The applicant is proposing to improve the property with a food manufacturing facility that will include space for manufacturing, warehousing and an office. The proposed structure is proposed to be of tilt wall concrete construction for each façade.

The applicant is requesting an appeal of the building design standards to allow the west facade of the new building that faces River Road to not provide vertical or horizontal articulation.

Horizontal Articulation - providing required offsets. Section 5.22-3(c)(1).

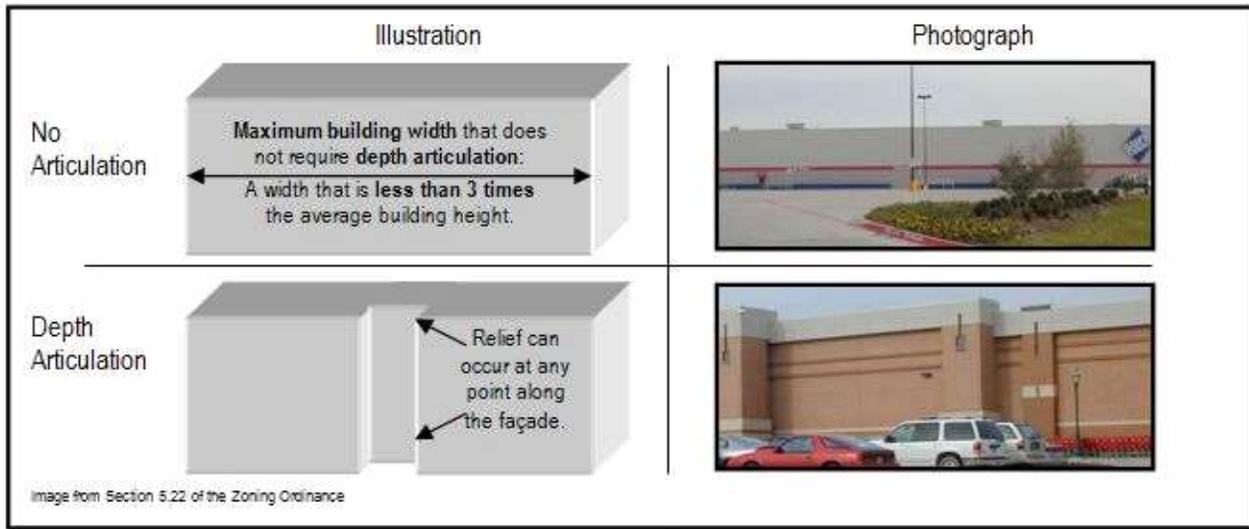
- The width of the west façade of the proposed building, facing River Road, is 150 feet with an average height of 34 feet. According to the design standards, no portion of the façade shall extend for more than three times the average height ($34' \times 3' = 102'$) without depth articulation (a change in the depth of the wall; in or out). To meet the design standards, there would need to be:
 - One horizontal offset (relief, in or out from the façade) at least 5.1 feet deep (15 percent of the average building height);
 - That that extends at least 15 feet in length;
 - Located or positioned on the façade so that no segment of the façade would extend for more than 102 feet without a 5.1-foot deep offset.
- The offset could be an inset or a protrusion as depicted in the following illustration.

- The west façade of the proposed building does not meet the horizontal standard since the building provides no horizontal articulation offset (see Attachment “Façade Elevation Drawing”).

1. A minimum of one additional tree and four shrubs for every 25 feet (or portion thereof) of the 150-foot building facade facing River Road (6 trees and 24 shrubs) from the approved plant list (zoning ordinance: chapter 144).
2. The above requirements shall be planted within 20 feet of the building facade.
3. Trees and shrubs shall be evenly spaced along the subject façade to avoid clustering.
4. All new trees shall be provided with a permeable surface of 60 square feet per tree under the drip line. All planting areas shall be a minimum of five feet in width.

1. Provide an appropriate wall mural based on New Braunfels history and/or Titos history that encumbers a minimum width of 40 feet on the River Road facing façade. Positioned on the 150-foot façade so that no more than 102 feet of the façade is outside the mural.

Vertical Articulation - providing required changes in elevation. Section 5.22-3(c)(2).

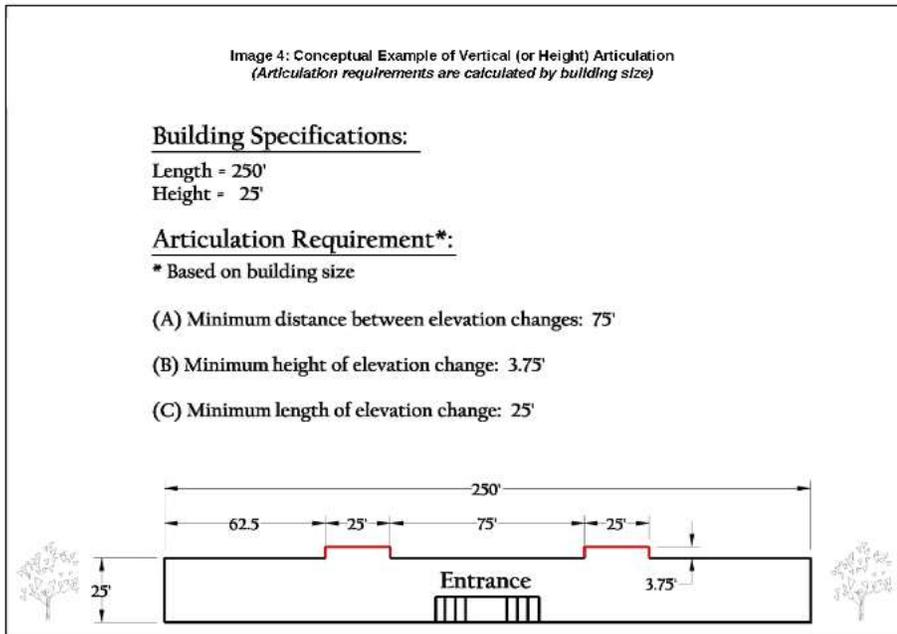
- According to the design standards no wall shall extend for more than three times its average height (34’ X 3 = 102 feet) without a change in elevation (the top of the wall or the roofline). To meet the design standards there would need to be:
 - One change in elevation of the façade of at least 5.1 feet (15 percent of the average building height);
 - That that extends at least 15 feet in length;
 - So that no portion of the façade would extend for more than 102 feet without an elevation change.
- The elevation change would be calculated as depicted in the following illustration.

- The west façade of the proposed building does not meet the vertical standard since the building does not provide any elevation changes (see Attachment 4) and extends for a length of 150 feet.
